ITEM FOR ENVIRONMENTAL COMMISSION AGENDA

NAME & NUMBER OF PROJECT: Additional 300K Ground Water Storage Tank Improvements 360 SP-2019-0417D

Development Services Department
Staff Recommendations Concerning Required Findings

Project Name: SP-2019-0417D Additional 300K Ground Water Storage Tank Improvements 360
Ordinance Standard: Watershed Protection Ordinance
Variance Request: For cut (LDC 25-8-341) exceeding 4 feet in depth in the Drinking Water Protection Zone

SITE DIMENSION PLAN

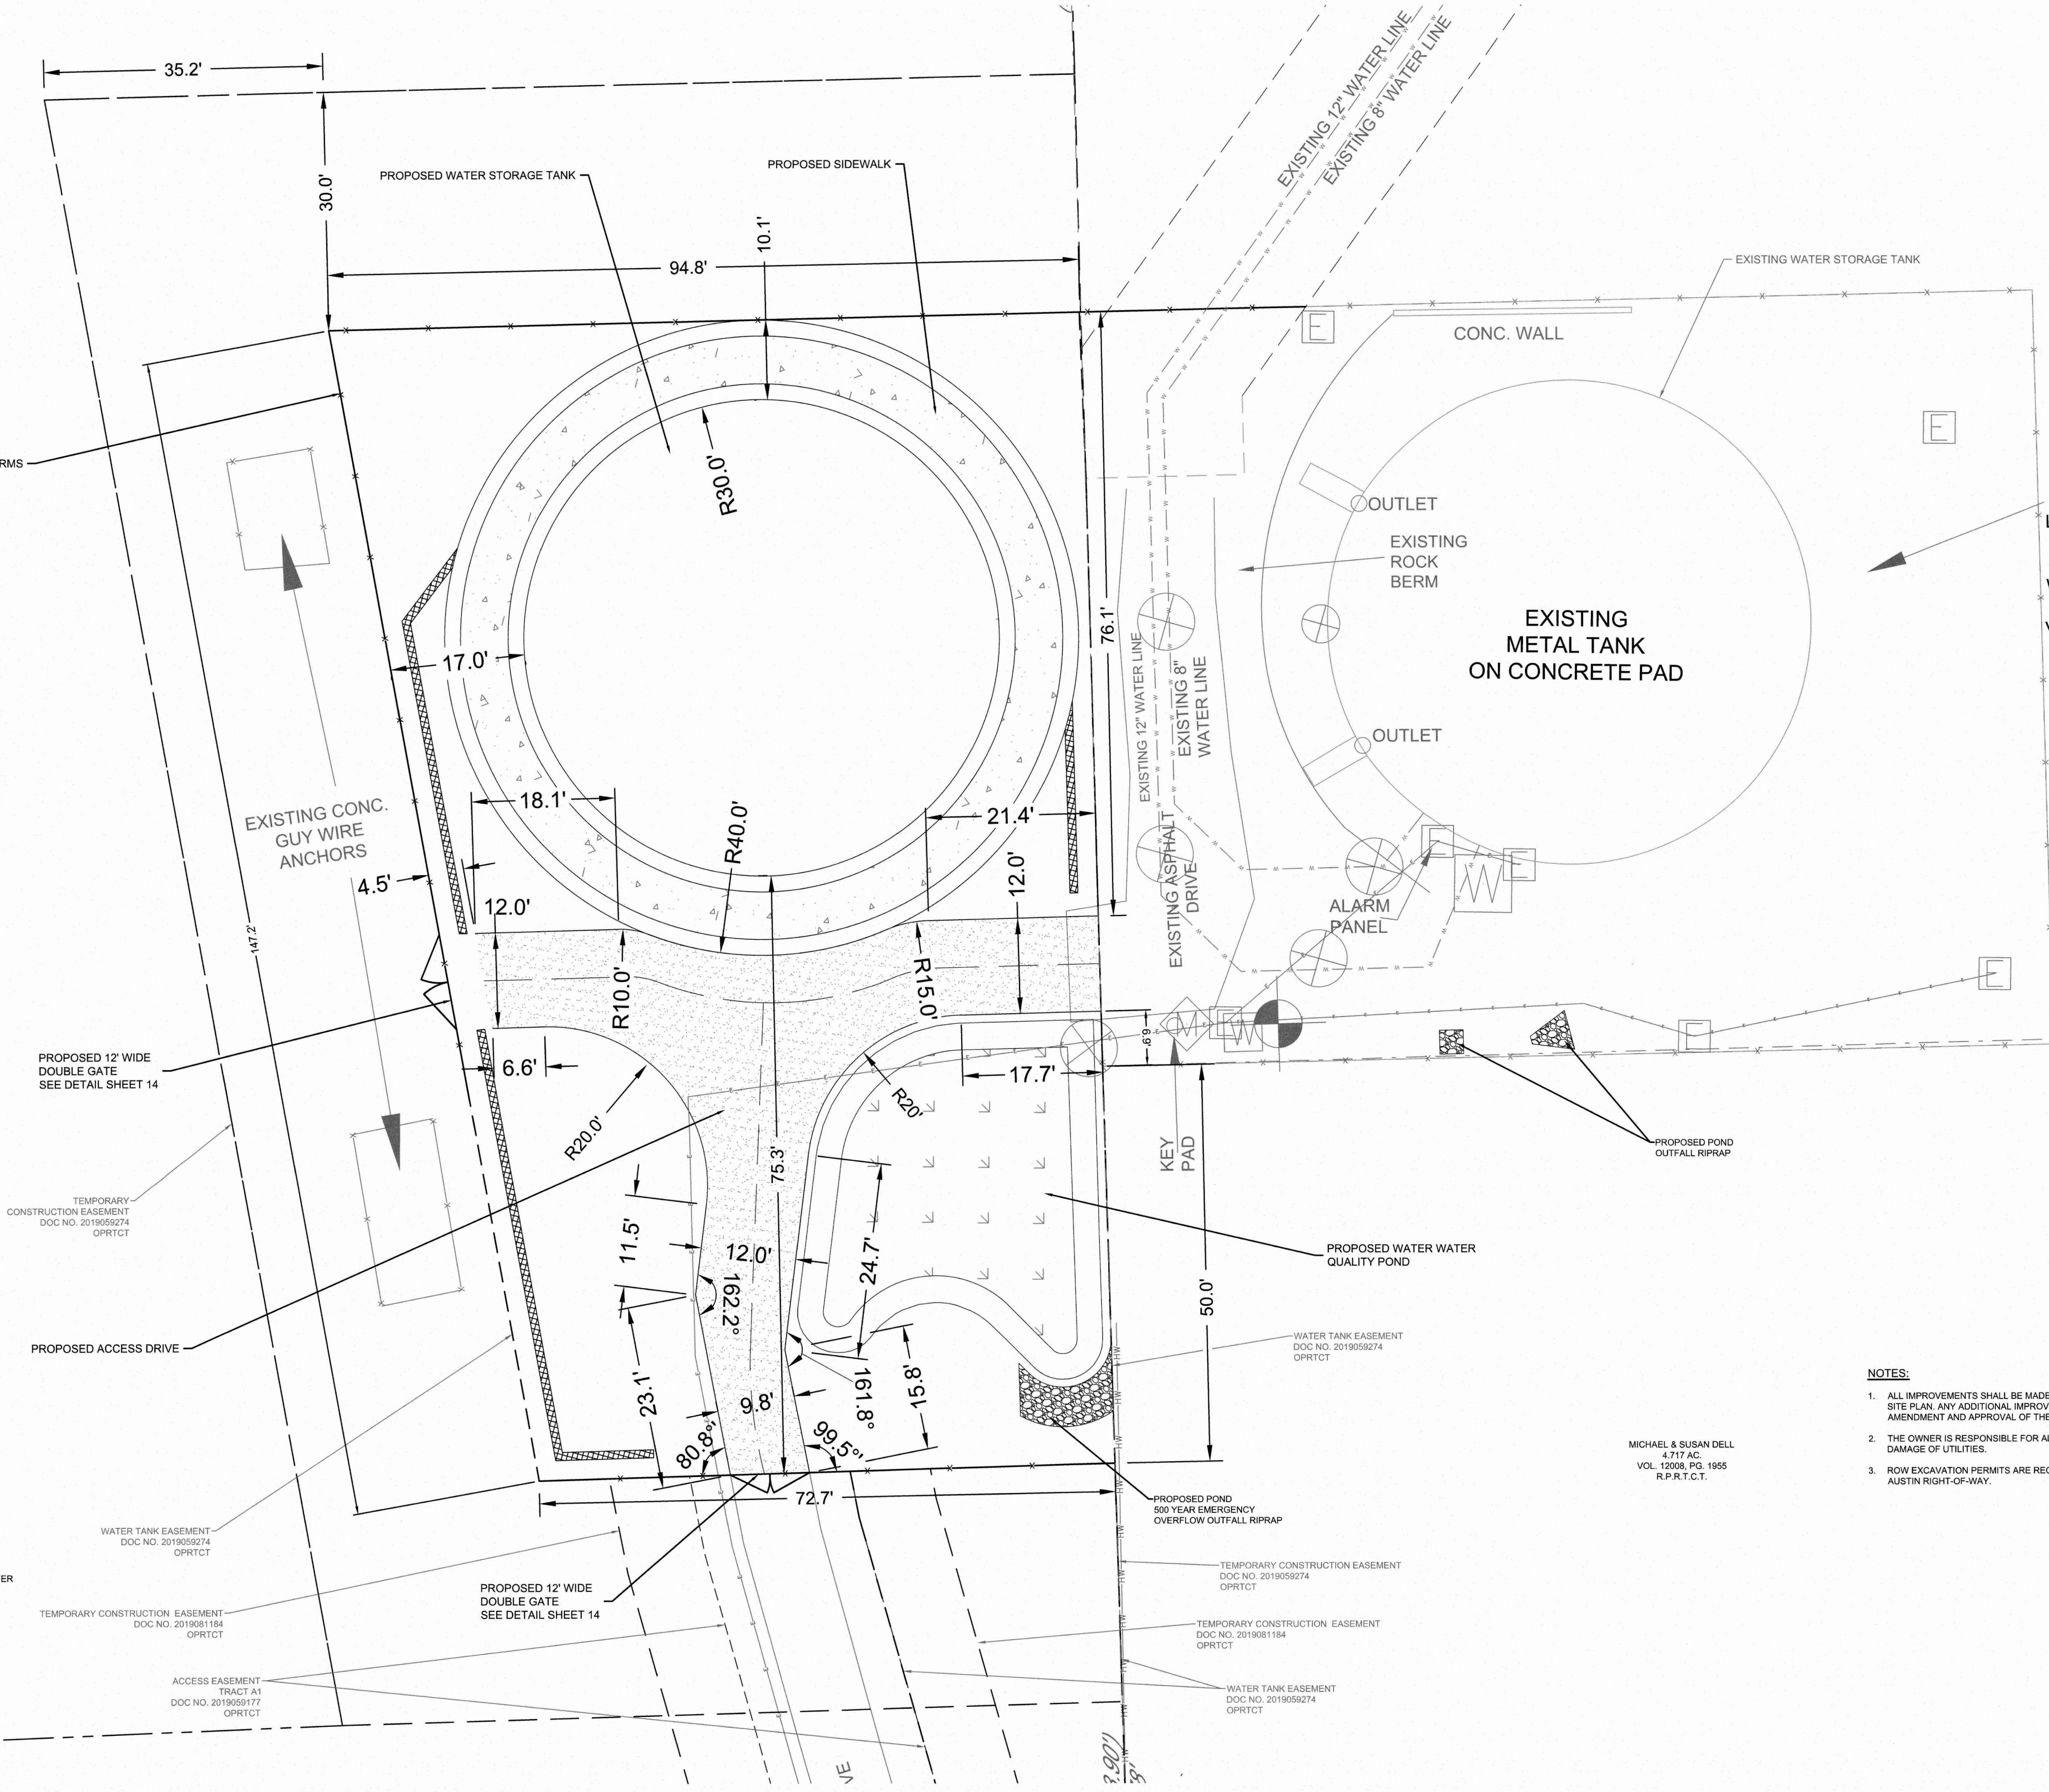
Yes The Loop 360 Water Supply Corporation is required to provide an additional 300,000 gallons of storage to its customers. The proposed water storage tank is designed to be connected to and support the existing tank that sits on the adjacent easement. The adjacent tank has an overflow elevation of 870 feet. Therefore, the proposed tank will also have an overflow elevation of 870 feet as it will be filled simultaneously by the same water pumps used for the existing tank. The cut in excess of four feet is needed so that the required 300,000 gallons of water storage is contained under the 870 foot elevation. In addition, the footprint of the tank

cannot be expanded because the tank must be designed to fit within the allotted easement. Within this easement, there is also surface area required to provide a sidewalk / concrete trickle channel to convey overflow drainage towards the pond and an earthen berm that will prevent off-site surface water flows onto the site. Furthermore, the allotted easement cannot be expanded as there are two existing guy wire anchors for the communication tower immediately adjacent to the west of the project site. Options to adjust the location or configuration of the proposed tank are infeasible based on the site characteristics unique to this property and based on the required design specifications for the proposed tank. See Staff Exhibit 1 – Proposed Site Plan.

Staff Determination: Staff determines that the findings of fact have been met. Staff recommends the following conditions:

1. Preserve the following trees next to the hammer head turnaround the water quality pond and the water tank: #524 Cedar; #525 Cedar; #526 Cedar; #527 Cedar and #534Cedar.
2. Re-vegetate all disturbed areas including the staging and storage area near the Buckman Mountain Road with City Standard Specification 604S.6 Native Grass and Forb Seeding.
